# Access Compliance Report

## Public Rights-of-Way

### (Curb Ramps)

Intersection ID: 13197	Main Street: S_MCDOWELL_ST	Cross Street: E_4TH_ST	Location: N
ADA ID: 08855FBE57A6	Ramp Type: Perp	Initial Pass/Fail: Fail	Overall Compliance: No
Severity Score: 33.75			
Codes/Mitigation Info/Possible Solution		Field Measurements/Component Compliance

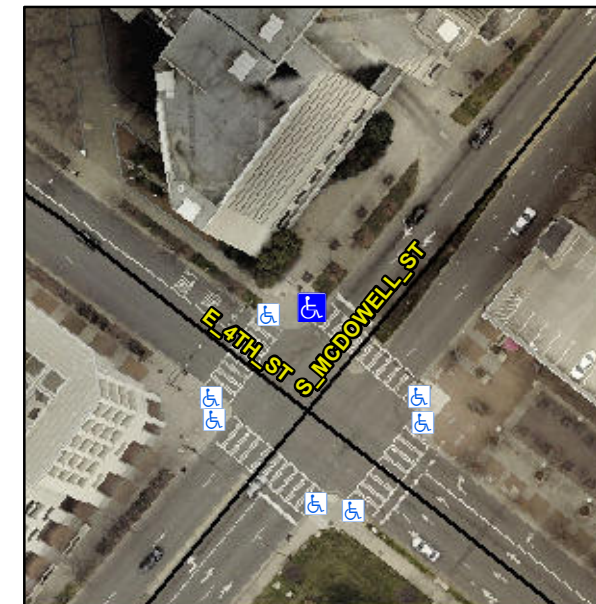
**Not Found, R304.5.1, R304.5.3**

Compliance	Description	Data	Compliance	Description	Data
N/A	Ramp Length (in)	55.0	Yes	Ramp Slope (%)	4.4
No	Ramp Width (in)	45.0	No	Ramp XSlope (%)	10.7
N/A	Flare Type LT	N/A	N/A	Flare Type RT	N/A
N/A	Flare Slope LT (%)	N/A	N/A	Flare Slope RT (%)	N/A
N/A	Flare Traversable LT?	N/A	N/A	Flare Traversable RT?	N/A
N/A	Landing Length (in)	N/A	N/A	DWS Provided?	N/A
N/A	Landing Width (in)	N/A	N/A	DWS Contrast?	N/A
N/A	Landing Slope (%)	N/A	N/A	DWS Length (in)	N/A
N/A	Landing X Slope (%)	N/A	N/A	DWS Full Width?	N/A
N/A	Landing Curb? (Y/N)	N/A	N/A	DWS Offset (in)	N/A
N/A	Shared Landing?	N/A			
N/A	Gutter Ponding?	N/A	N/A	Gutter Slope (%)	N/A
N/A	Gutter Lip Ht (in)	N/A	N/A	Gutter X Slope (%)	N/A
N/A	Painted X Walk1?	Yes	N/A	Painted X Walk2?	N/A
	X Walk 1 Direction	To SE		X Walk 2 Direction	N/A
N/A	X Walk 1 Width (in)	150.0	N/A	X Walk 2 Width (in)	N/A
	X Walk 1 Slope (%)	0.1		X Walk 2 Slope (%)	N/A
	X Walk 1 X Slope (%)	4.3		X Walk 2 X Slope (%)	N/A

**Remove & Replace Entire Ramp.**
